## Oxfordshire Liveable Streets

### Response to consultation “Countywide - proposed Electric Vehicle charging only parking spaces (July 26)”

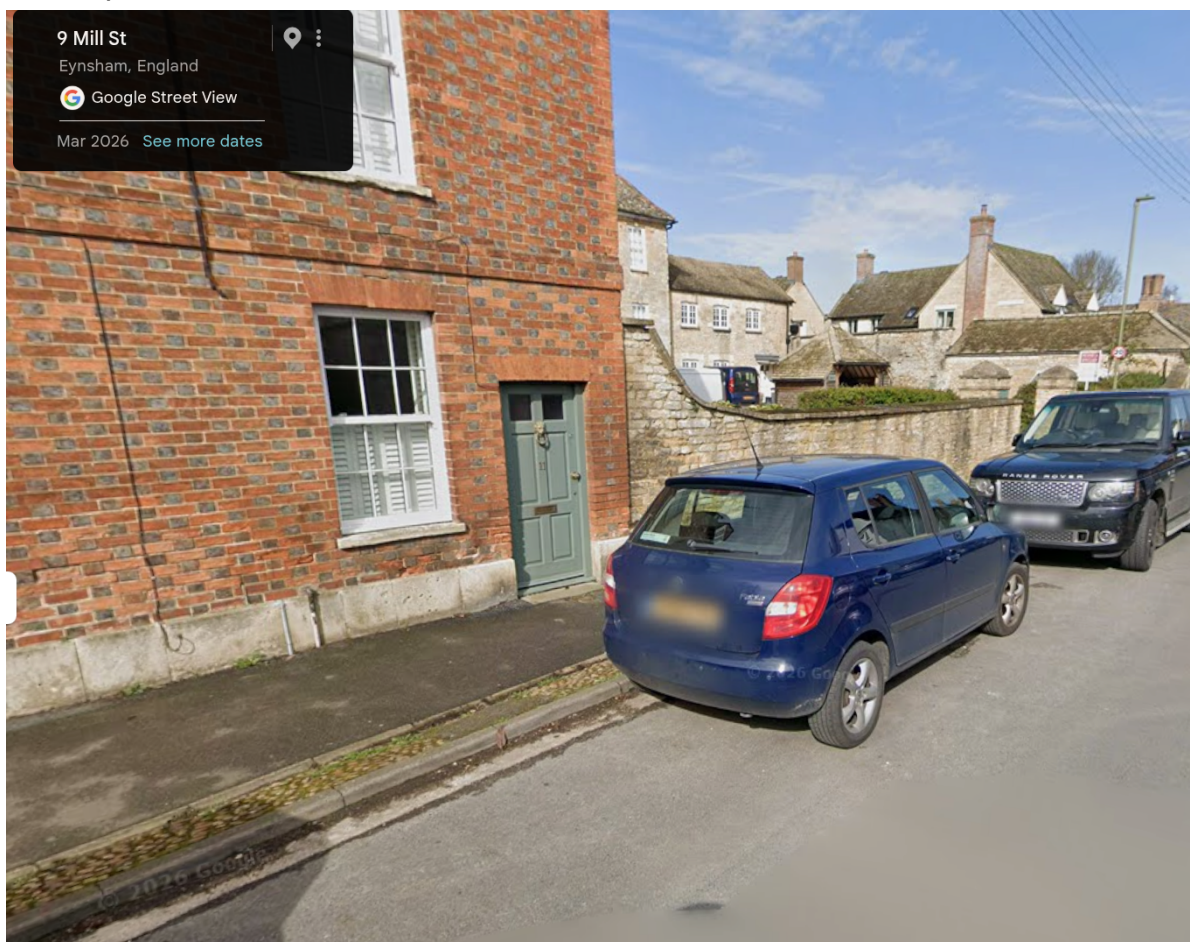
There is no footway involved.
